STAFF REPORT
PLANNING COMMISSION

FILE NO.: PDC10-025

PROJECT DESCRIPTION:

Planned Development Zoning from the R-1-8 Single-Family Residence Zoning District to the A(PD) Planned Development Zoning District to allow for the development of up to 96 single-family attached residences on a 4.30 gross acre site.

**REVISED SITE PLAN
SETBACK EXHIBIT
(May 6, 2011 Submittal)**

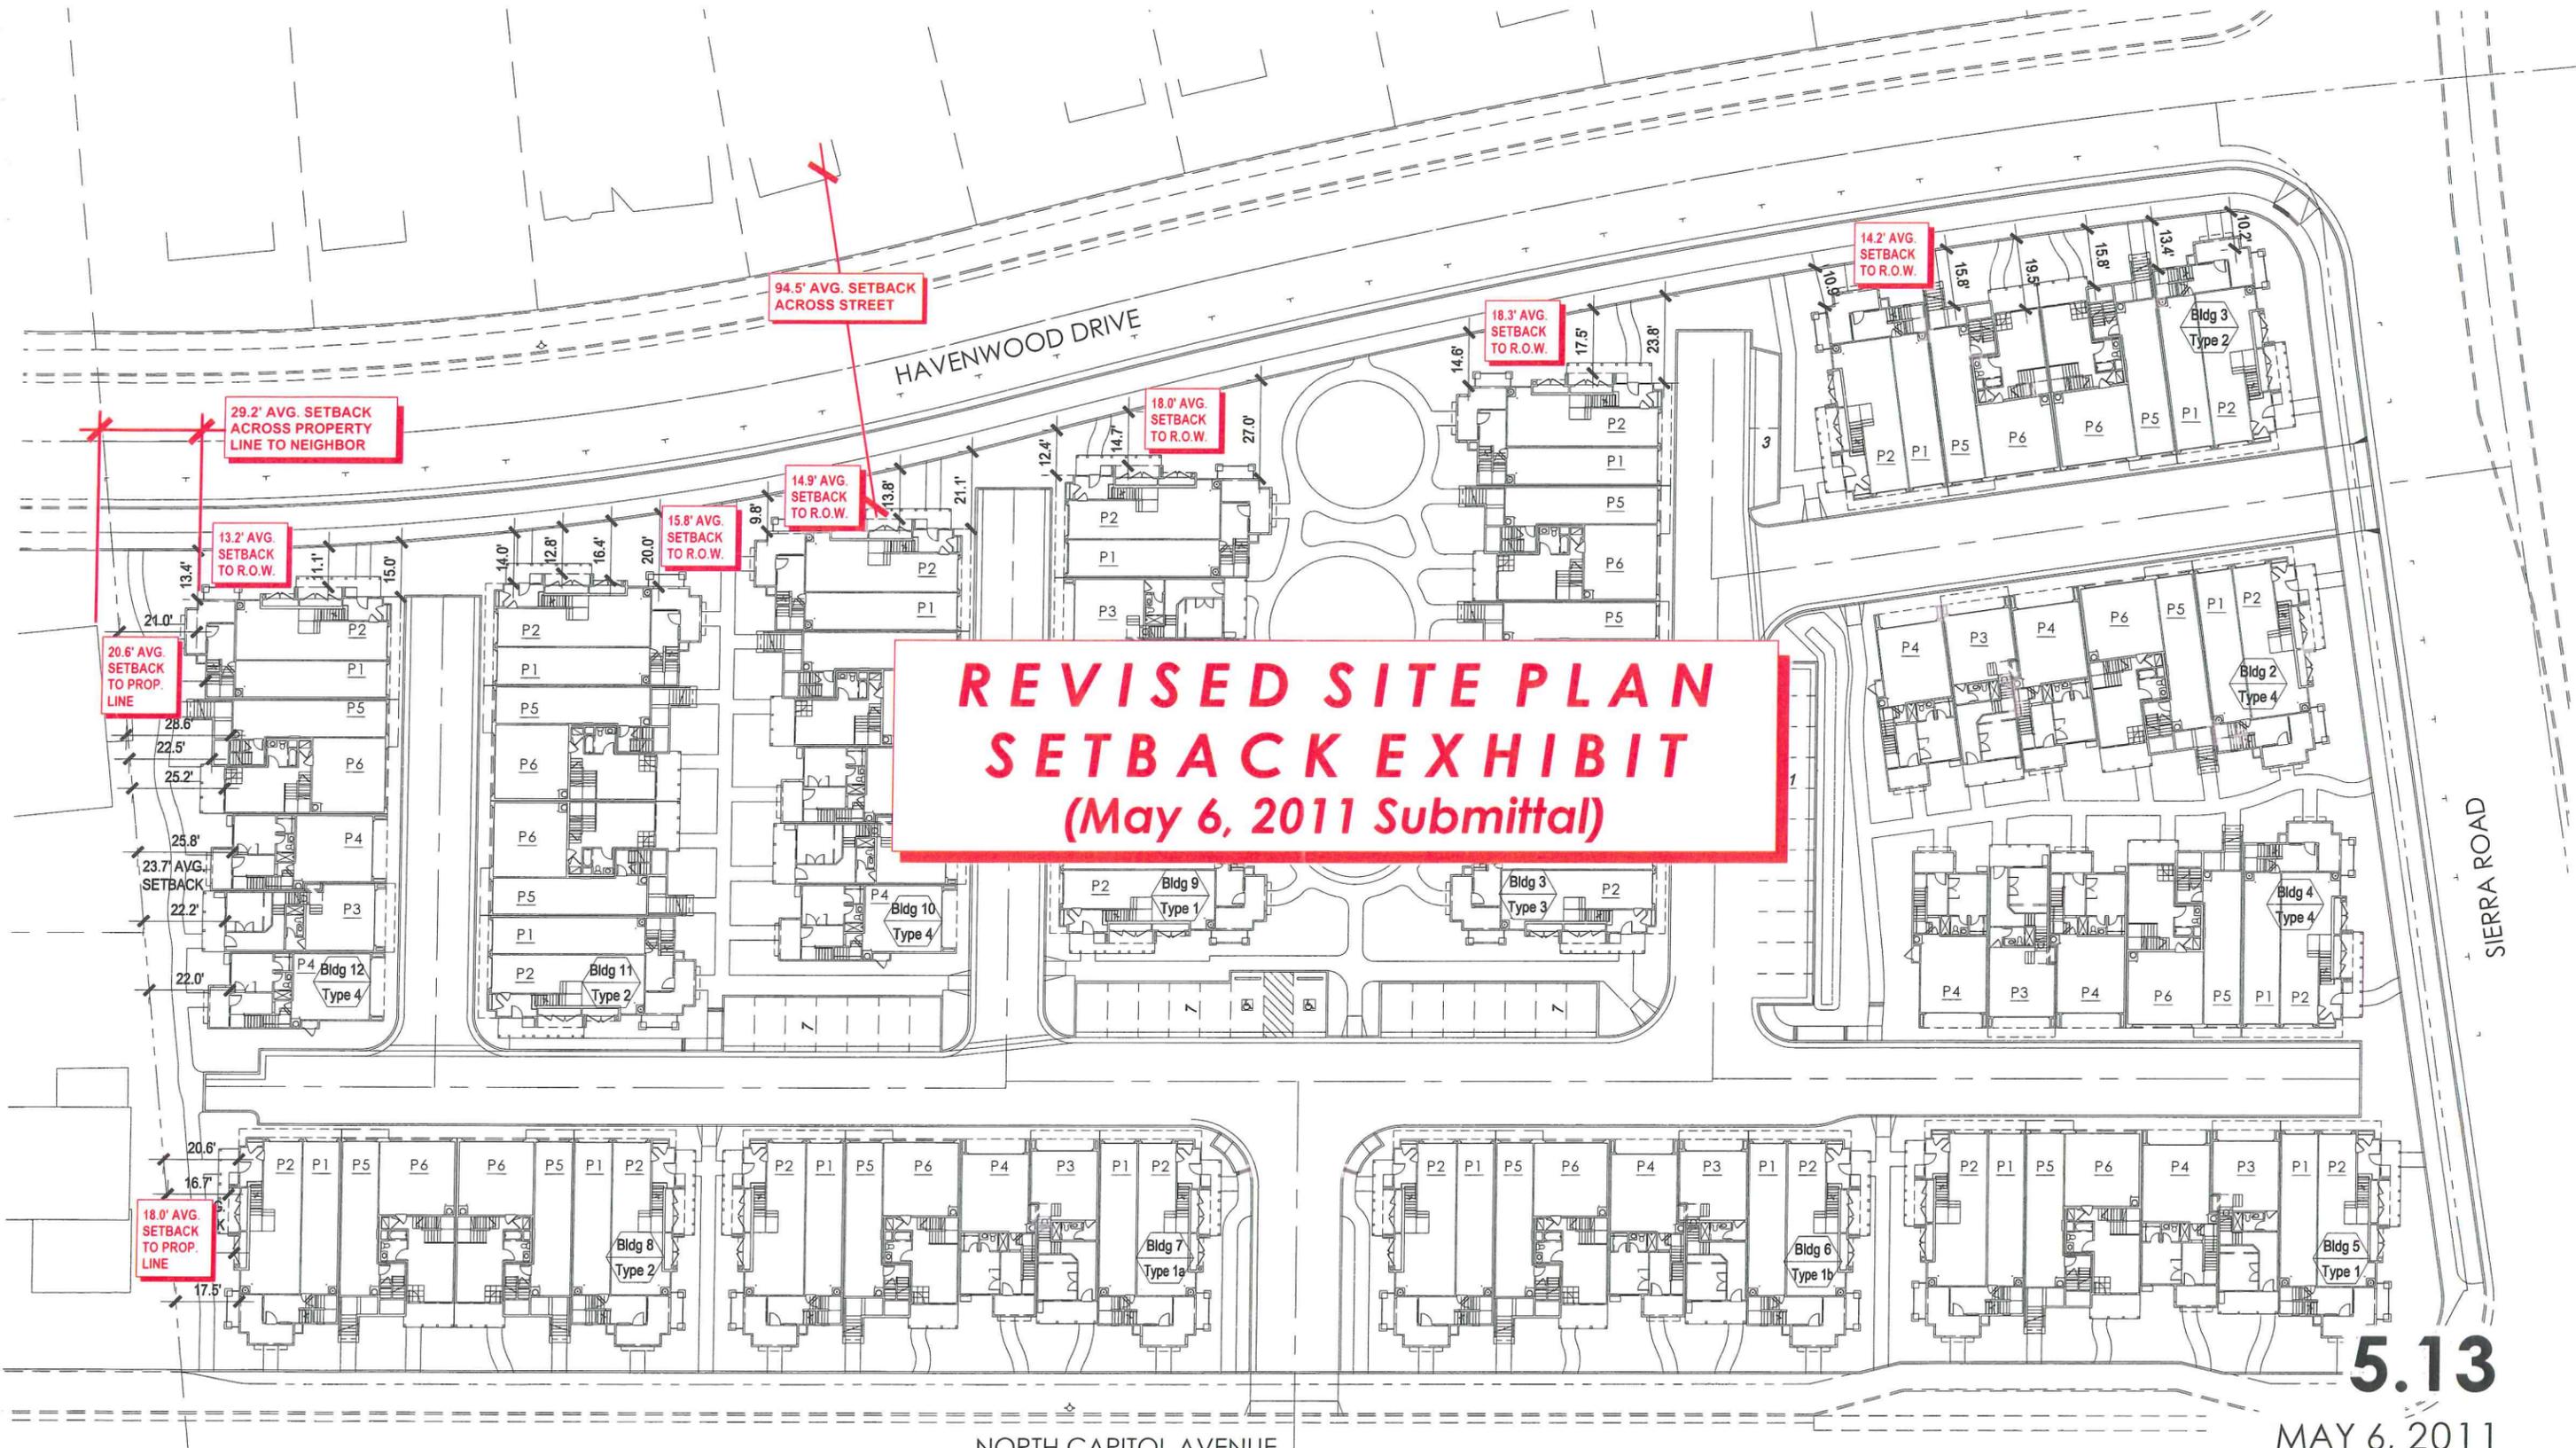
1. The building setback from Havenwood Drive shall be 25 feet for three-story buildings consistent with the Residential Design Guidelines.
2. The building setback from the northern property line shall be 33 feet consistent with past practices of similar developments in the City of San Jose.

Staff does not support the request for reduced setbacks at the northern and eastern property lines given the proposed three-story building height and relationship to existing single-family houses. In neighborhoods where redevelopment of adjacent single-family properties to a more intensive use is reasonably foreseeable, based on the adjacent General Plan designations, the City has been slightly more lenient with respect to imposing the 2:1 setback recommendation for three-story structures. However, the adjacent single-family residences are not likely to ever redevelop given the fact that they are currently zoned as such, have a San Jose 2020 General Plan designation of 8 DU/AC, and a proposed designation of Residential Neighborhood 8 DU/AC on the Draft 2040 General Plan Update.
